KV6\KV8 Series Villa Door Station Firmware V2.2.53_220816 Release Note

Device Model	DS-KV6103-PE1(B)、DS-KV6113-PE1(B)、DS-KV6113-WPE1(B)、DS-KV8113-WME1(B)、
	DS-KV8213-WME1(B)、DS-KV8413-WME1(B)
Firmware Version	V2.2.53_220816
iVMS-4200 Version	Latest version
Hik-Connect APP	Latest version

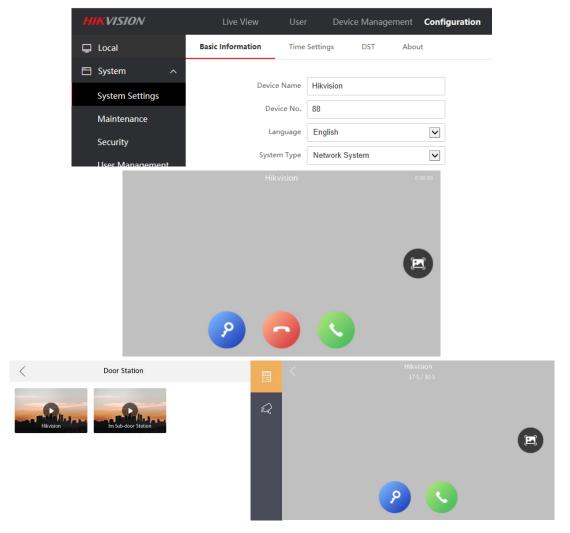
1. The changed name of the door station will be displayed on the call interface or live view interface of the indoor station

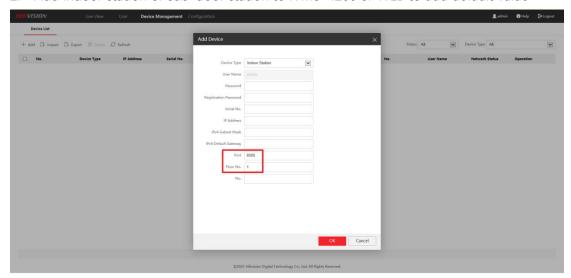
2. Add indoor station or sub-door station to iVMS-4200 or WEB to add default value

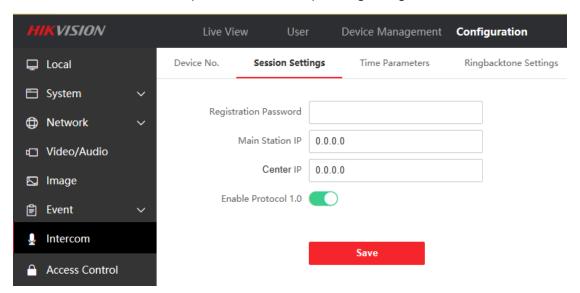
- 3. If the Registration Password in the door station WEB interface has been configured, it will be displayed in cipher text
- 4. Video Intercom Server IP (Private SIP server IP) naming changed to Center IP

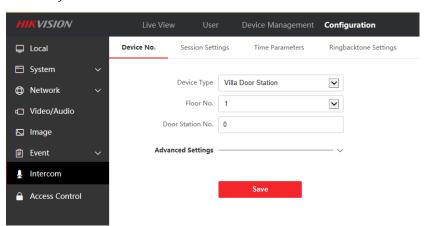
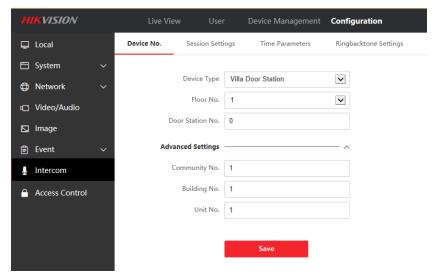
5. The WEB or iVMS-4200 interface community number, building number, and unit number of the door station will be stored in the advanced settings column instead of being displayed directly

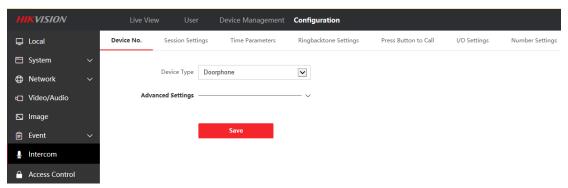
6. Support doorphone mode, when this function is enabled, the door station will no longer actively synchronize the information of the indoor station

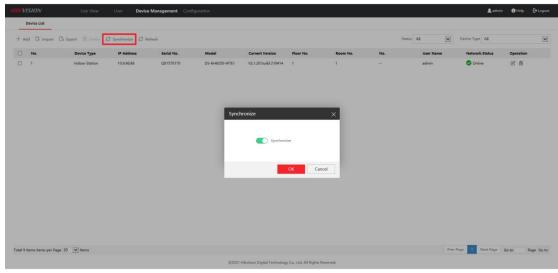
- 2. Regardless of lock 1 or lock 2, when the security module is connected, the security module is first enabled to control the lock
- 3. The synchronization function is enabled by default. Enabling this function means that the door station will periodically synchronize the parameters to all indoor stations or sub door stations connected to this door station (Synchronized content includes network parameters, community number, building number, unit number)

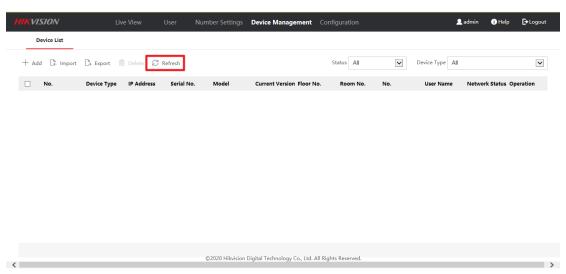
1. New refresh button is used to refresh the status of added devices

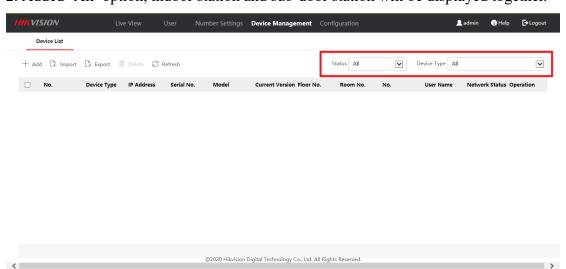
2. Added 'All' option, indoor station and sub-door station will be displayed together.

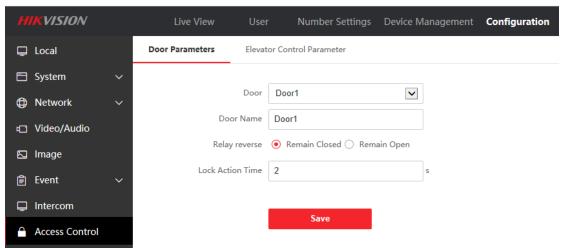
1. Modify the default unlocking time to $2 \, s$, and supporting unlocking time can be configured with $1\text{-}255 \, s$

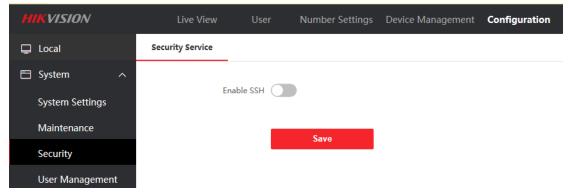
3. The user can remotely open the device SSH function through the WEB;

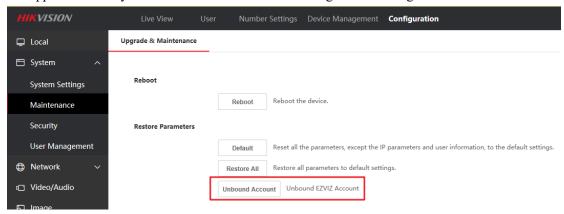
4. Support to actively unbind Hik-Connect account through WEB configuration
